To: Jonesfield Township Planning Commission
From: Alan Bean, AICP – Spicer Group, Project Planner (alanb@spicergroup.com)
Jennifer Stewart, AICP – Spicer Group, Community Planner (jennifer.stewart@spicergroup.com)
RE: Review of DTE's Meridian Wind Park Special Land Use Permit Application – Site Plan Review

The following reports are a section by section review of the Meridian Wind Park in Jonesfield Township. The project proposes 26 WTG Tower locations and a substation. The proposed improvements are located in Sections 1 – 4, 9 – 14, 16, 21 – 22, and 24.

JONESFIELD TOWNSHIP – SECTION 3

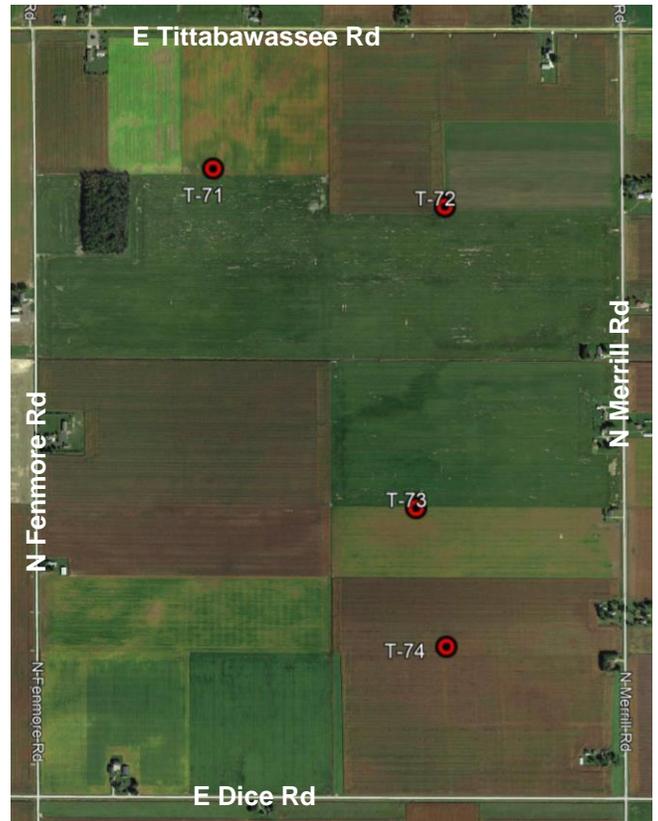
Shadow flicker – In the Shadow Flicker Analysis, DTE has indicated that turbines 71, 72, 73, and 74 will be curtailed so as not to contribute more than 30 hours of shadow flicker per year to the surrounding homes. This aligns with the May 15, 2019 design parameters letter. For further details on curtailment, see DTE's Appendix A of the Shadow Flicker Analysis dated April 20, 2021.

The proposed access roads for turbines 71, 73, and 74 are all adjacent to non-participating properties. Section 907(4)(E) of the Zoning Ordinance states any improvements shall maintain stormwater run-off at a pre-development rate and should not have any off-site impacts. DTE has submitted a Hydrology Memo that addresses these specific turbine sites. Spicer recommends that the approved access roads are designed so that any additional run-off from the project is directed away from the adjacent non-participating properties.

JONESFIELD TOWNSHIP – SECTION 10

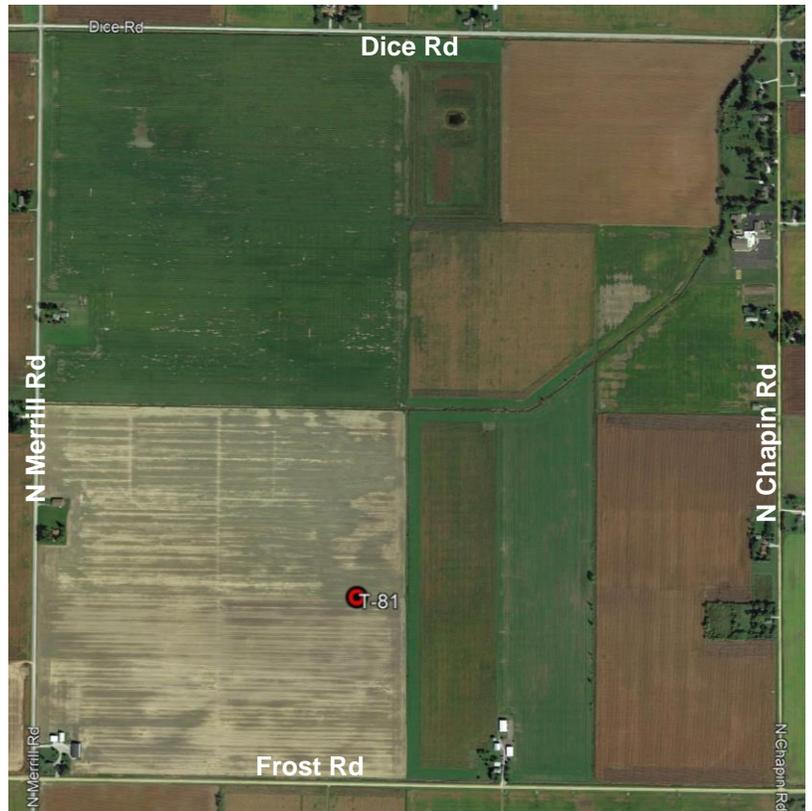
Setback Requirements: The proposed improvements meet the setback requirements of the A-1 Agriculture zoning district.

Driveway and Parking: The applicant is proposing an access drive off Dice Road. The access drive and proposed parking meet the zoning ordinance standards.

Fence: The proposed site plans indicates an 8' tall chain link fence with barbed wire. The fence meets the Zoning Ordinance standards.

Drainage: The recommendations for stormwater and drainage on the site are addressed in the site plans. The applicant plans to hydroseed the site after construction. They've also proposed a berm along the southern property line to mitigate off-site drainage impacts.

Temporary Construction Phases: The applicant is proposing a temporary topsoil stockpile with a silt fence and a concrete washout basin during construction. The concrete washout basin has been designed using best practices.

1. What is the long-term plan for the O&M Staging Area? Is the proposed parking in the O&M Staging area permanent?
2. What is the long term plan for the concrete washout basin?
3. Signage: The applicant has not proposed any signage. Do they intend to post emergency signage or general identification signage on the site?
4. Lighting: The applicant does not show any lighting on the site plans. Do they intend to have lighting on site?
5. Access Drive: Does the applicant have an approved permit on file with the Road Commission for the proposed access drive?

Site plan meets the criteria of the Zoning Ordinance. The applicant is required to seek the applicable permits related to the construction of this substation site from the following agencies: Saginaw County Road Commission, Saginaw County Public Works Commissioner, and/or the EGLE.

JONESFIELD TOWNSHIP – SECTION 14

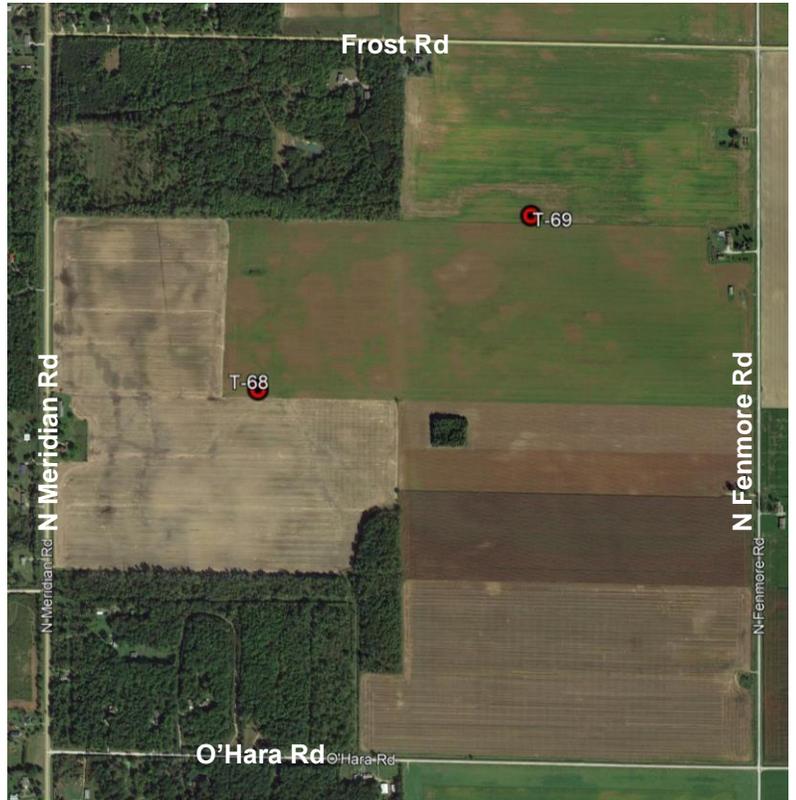
Shadow flicker – In the Shadow Flicker Analysis, DTE has indicated that turbine 82 will be curtailed so as not to contribute more than 30 hours of shadow flicker per year to the surrounding homes. This aligns with the May 15, 2019 design parameters letter. For further details on curtailment, see DTE’s Appendix A of the Shadow Flicker Analysis dated April 20, 2021.

JONESFIELD TOWNSHIP – SECTION 21

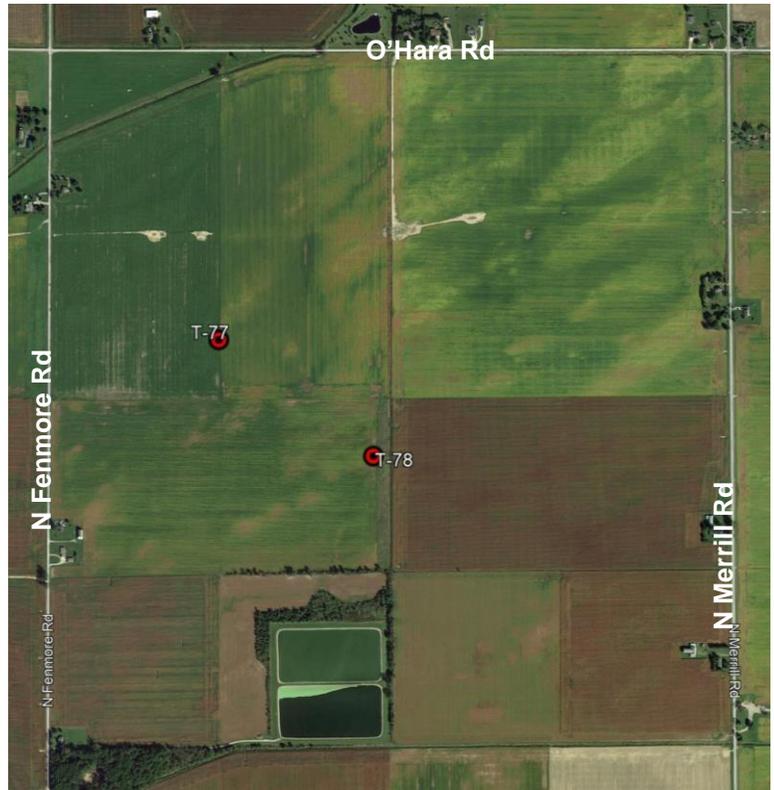
Shadow flicker – In the Shadow Flicker Analysis, DTE has indicated that turbine 70 will be curtailed so as not to contribute more than 30 hours of shadow flicker per year to the surrounding homes. This aligns with the May 15, 2019 design parameters letter. For further details on curtailment, see DTE’s Appendix A of the Shadow Flicker Analysis dated April 20, 2021.
